July 28, 1995

Re: **SMW-6 Well Replacement**  
**Giant Refining Company - Ciniza**  
**NMD000333211**

Giant Refining Company - Ciniza (Giant) submits the following responses to the questions in the July 25, 1995 letter from your office.

PROPOSED SMW - 6A WELL DIAGRAM

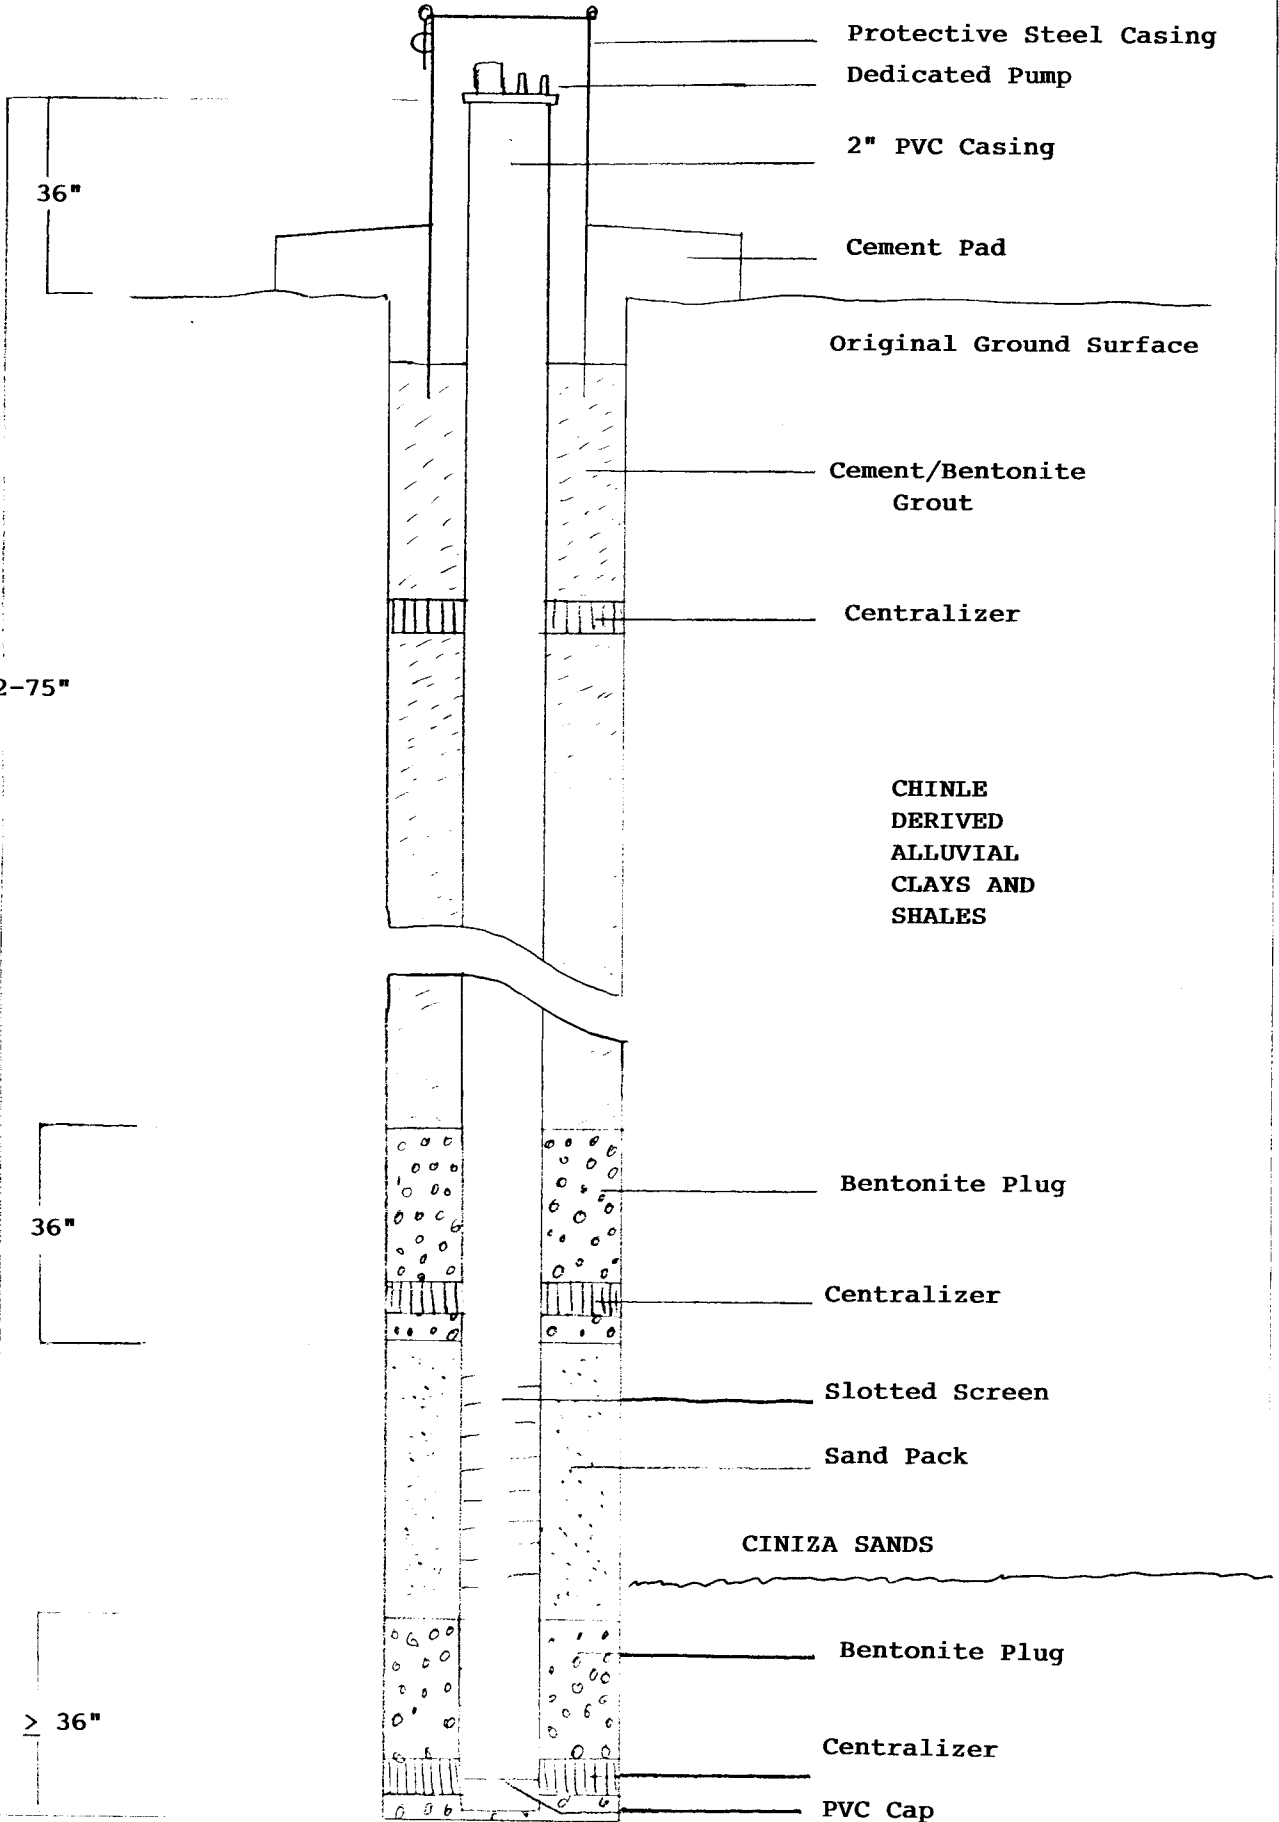
- 4) In the 8th paragraph you state GRC does not consider the abandonment of SMW-6 and its replacement with SMW-6A to be permit modifications. Because the proposed well, SMW-6A, will replace a monitoring well which may be damaged and/or will have a different design than the existing well, SMW-6, a permit modification may be required. Please submit a more detailed diagram (e.g. where the centralizers will be placed, slot size, thickness and location of bentonite plug above the slotted screen, height of top of casing above ground level, radius of concrete pad, etc.) than the well diagram sent with your July 6 letter.

Giant still does not believe that the replacement of SMW-6 with SMW-6A should be a permit modification. Although technically the design of SMW-6A is an improvement on the design of SMW-6, the function of the well within the permit is exactly the same. The same constituents, sampling interval (Spring/Fall), geologic formation, and reporting requirements of SMW-6A are identical to those of SMW-6. Only the physical location of the wellbore will change very slightly.

A list of construction details of SMW-6A are listed below:

Total depth	72' to 75'
Casing size and type	2" PVC (flush screw joints)
Sand packing	16 - 40 sand
Screened casing	.010" slots
Bentonite seal-bottom	≥ 3' bentonite pellets
Bentonite seal-top	3' bentonite pellets (immediately above sand pack)
Height of casing	36" above ground level
Steel protective casing	2' into grout
Cement pad	36" x 36" x 6"
Screened interval	Ciniza Sand formation only

Stainless steel - bottom of pipe,  
top of screen, and every 20' to  
surface

The cement pad will be 3' x 3' x 6" and sloped away from the protective casing. The protective casing will be installed 2' into the grout. A locking cap will be installed on the protective casing. A centralizer will be installed at the bottom of the casing, at the top of the slotted screen casing and at  $\geq 20'$  intervals to the surface.
